Division of Surface Water Response to Comments

National Pollutant Discharge Elimination System (NPDES) General Permit for Discharges of Storm Water Associated with Construction Activity Located within Portions of the Olentangy River Watershed

Ohio EPA General Permit No.: OHCO00002

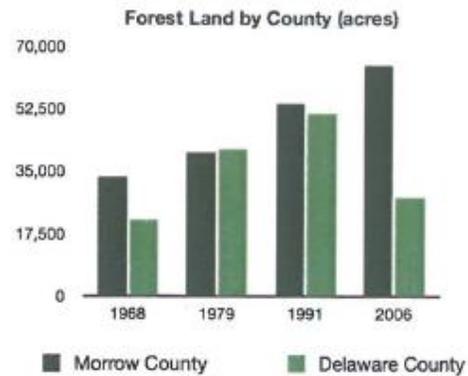
Comment 42: **FLOW understands that Ohio EPA is going to change the permit language to reflect the new 12 digit hydrologic unit code (HUC) boundaries. There are several major changes in the boundaries between the 14 digit boundaries and the 12 digit boundaries. FLOW has not had a chance to evaluate what the impact of this change will be. Please see the attached example.**

Response 42: Ohio EPA's Integrated Report and TMDLs use a 12-digit HUC scale. For consistency, Ohio EPA has updated this

permit and replaced the referenced 14-digit HUC watersheds with 12-digit HUC watersheds. By switching to the 12-digit HUC, the most southern 12-digit HUC (05060001 11 02) extends further south than OHCO00001's original permit area. In order to not change the permit area, only a portion of this 12-digit HUC will be applicable and will have the same most southern boundary as was applicable in the previous generation permit.

It is important to note that the permit area boundaries have not changed. The permit area for OHCO00002 will include the following 12-digit HUCs and are identified in Part I.A of the permit:

12-digit HUC
05060001 09 02
05060001 09 01
05060001 09 03
05060001 10 07
05060001 11 01
05060001 11 02 (Only portion as depicted in map)

Please see Attachment A of the permit for permit area boundaries. An electronic version of Attachment A can be viewed at
http://epa.ohio.gov/dsw/permits/GP_ConstructionSiteStormWater_Olentangy.aspx
